TECHNICAL MEMORANDUM

To: Housing Authority of the City of Santa Barbara

From: Waterways Consulting, Inc.

Re: Gardens on Hope – Creek Setback Analysis

ARROYO BURRO CREEK SETBACK ANALYSIS
CONCEPTUAL CROSS SECTIONS

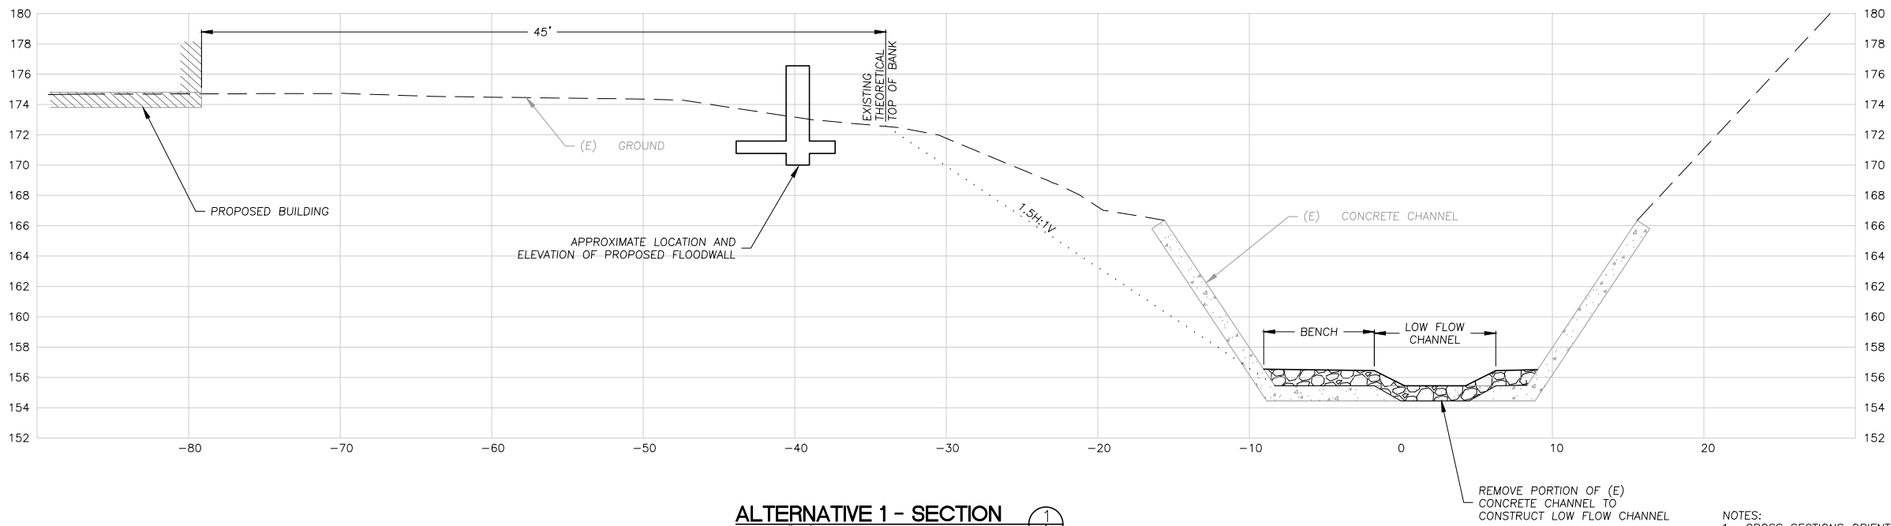
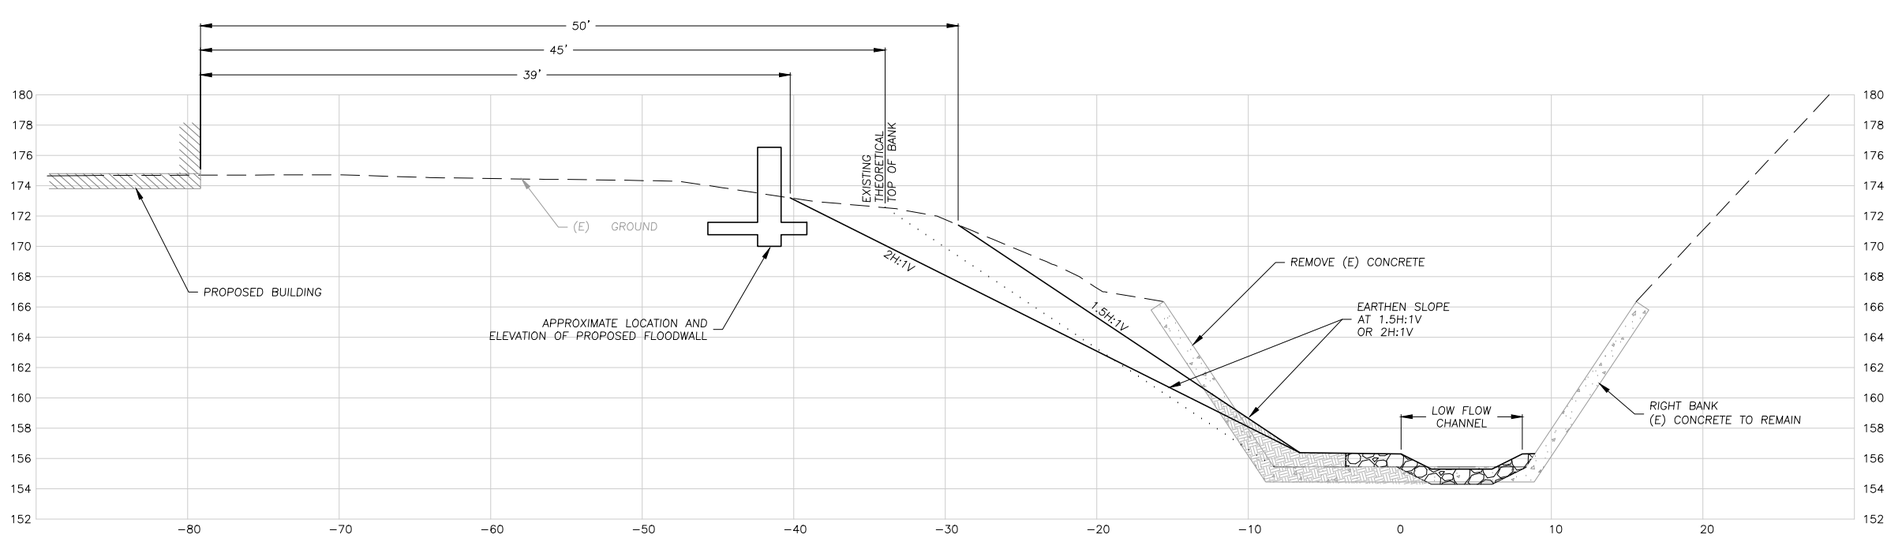
Alternative 1, as presented in **Figure 1**, calls for the removal of a portion of the concrete channel bottom and the placement of Engineered Streambed Material (ESM) to create a low flow channel and small bench. The enhanced channel bottom would focus low flows and create flow depth complexity necessary to improve Steelhead passage and improve habitat for other aquatic species. The concrete banks would be preserved to minimize disturbance to the existing slope and riparian vegetation, and to help alleviate the risk of bank erosion and channel migration.

The cross sectional area for this alternatives is approximately the same as existing conditions, however channel roughness would increase along the channel bottom due to the placement of ESM resulting in slightly higher flood elevations. A floodwall set to height of 3 feet above 100-year flood elevations (as also proposed by Questa) is proposed at the top of bank. This alternative has not been modeled for hydraulic impacts at this stage.

Alterative 1 does not change the existing left bank slope and therefore results in a 45 foot setback from the theoretical top of bank to the proposed apartments.

Alternative 2, as presented in **Figure 1**, calls for the removal of the concrete channel bottom as well as the left bank. Similar to Alternative 1, ESM would be placed within the channel to create a low flow channel and small bench. The left bank could be graded to a 1.5:1 or 2:1 slope and planted with native riparian vegetation. The right bank would remain concrete to minimize disturbance to the existing slope and riparian vegetation higher on the slope.

The cross sectional area for this alternatives are slightly greater than existing conditions, however channel roughness would increase along the channel bottom and left bank due to the placement of ESM and the restoration of riparian vegetation. This would result in slightly higher flood elevations.
A floodwall set to height of 3 feet above 100-year flood elevations (as also proposed by Questa) is proposed at the top of bank. This alternative has not been modeled for hydraulic impacts at this stage.

Alternative 2 maintains a 50 foot setback using a 1.5:1 slope and a 39 foot setback using 2:1 slope from the new top of bank to the proposed apartments.
